Final Supplemental Environmental Impact Report Pasadena-Los Angeles Light Rail Transit Project

Contract ENO-26
CWO No. -002
May 1994

| | Page |
|--|------|
| 2.0 RESPONSES TO COMMENTS..... | 2-1 |

FIGURE 2-1 MARMION WAY/FIGUEROA STREET BELOW-GRADE SEPARATION

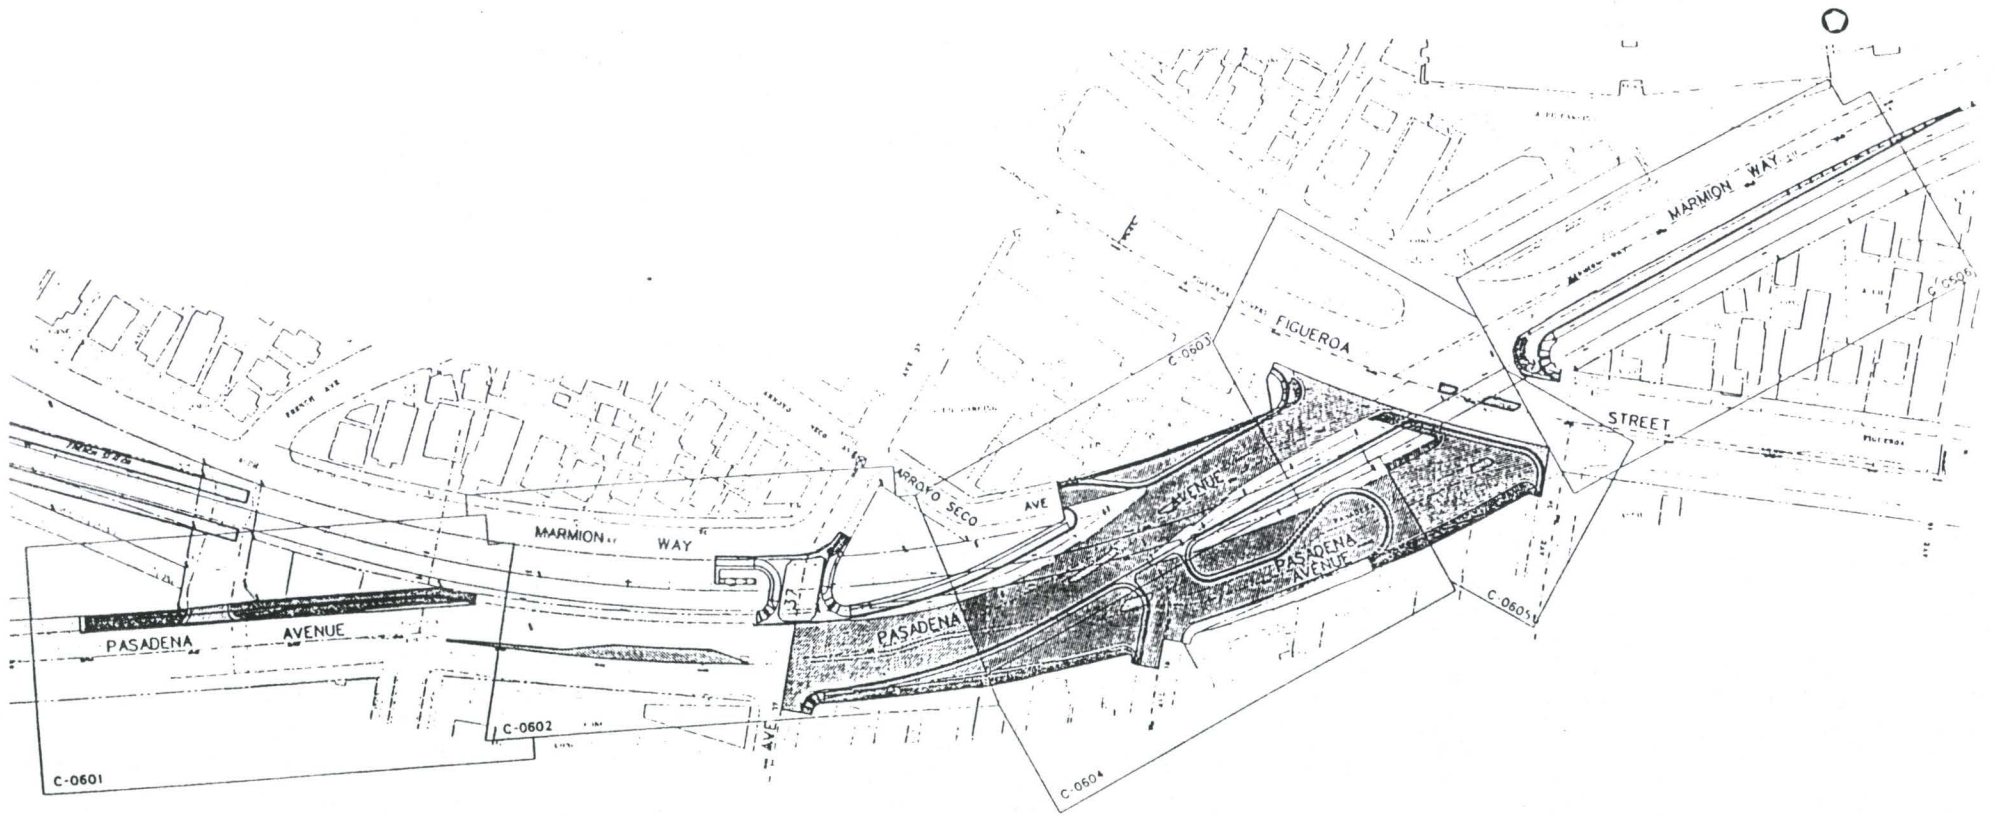
"I request that a concept wall site plan of the grade separation at Marmion and Figueroa be included in the Supplemental Environmental Impact Report prior to its certification." (David Kuehn, Los Angeles, Public Hearing 4/13/94)

See Figure 2-1 in Section 2.3.

The below-grade site plan proposed for construction in the vicinity of Marmion Way and Figueroa Street is presented on Figure 2-1.

FIGURE 2
LACY STREET
PRODUCTION
CENTER
FACILITIES

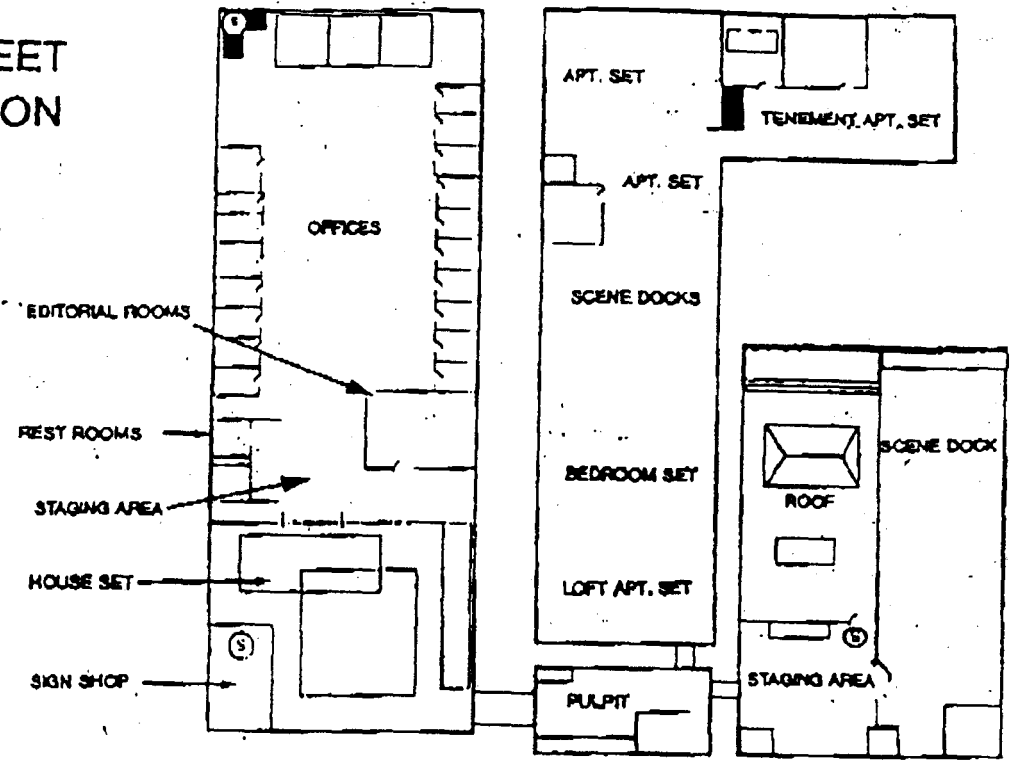
"Station construction and operation will require different considerations with respect to the studios. A portion of the "chop shop", indicated on Figure 2 as the garage set, abuts the 26th Street Station area. The need to mitigate noise levels on this side of the complex is critical and there needs to be considerable thought given to the architectural treatment along 26th Street as it relates to the station architecture (textures, colors, materials). The increased levels of noise from doors, horns, gongs, and parking lot activity should be considered in the SEIR and mitigated for an important facility such as a motion picture studio." (pp. 4 through 6)
